Government and Public Safety 1301 E. Algonquin Road Schaumburg, IL. 60196 FSB NUMBER: FSB10233B

Up Issued to include 'W' Series Control Head, increase the affected date range and to update the resolution

FIELD SERVICE BULLETIN

<u>SUBJECT:</u> XTL5000/XTL2500 High Power (100 Watt) Mobile Units may reset during transmit if equipped with a Universal Crypto Module, UCM (Secure).

Picture 1: Location of C916 for installation on a NNTN5032_ (or NNTN7247A/B) board

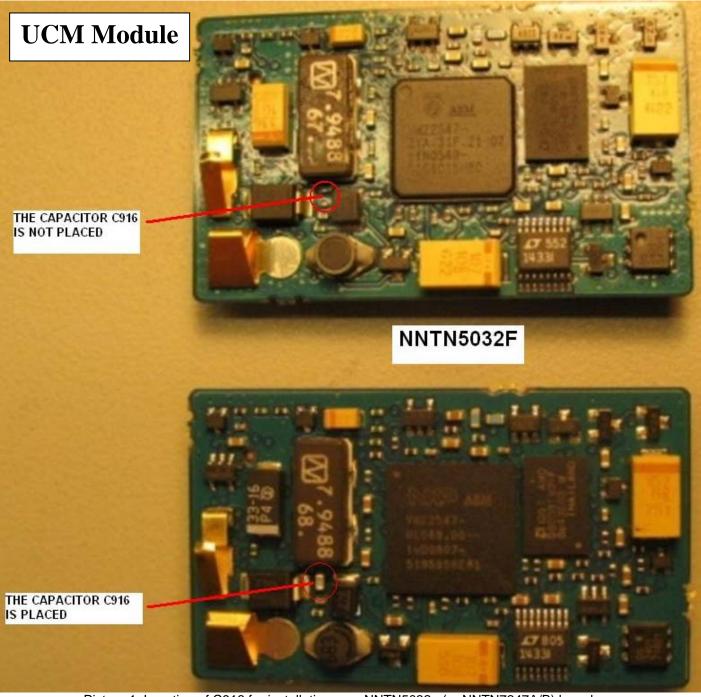
- b. If the part number is NNTN7427C, no rework is needed. Proceed with steps 6 thru 8.
- 2. Locate the capacitor location on the UCM: C916 (Shown on the NNTN5032F board in Picture 1)

- a. Note: Location placement of C916 is the SAME on NNTN7427A/B as it is for NNTN5032_ UCM kit
- 3. If C916 not installed, install/solder the new part, 2113944C47, in the C916 location

- 4. If board already has C916 installed, replace the existing part with a 150pF capacitor, part number 2113944C47
- 5. Visually inspect that the part is well soldered
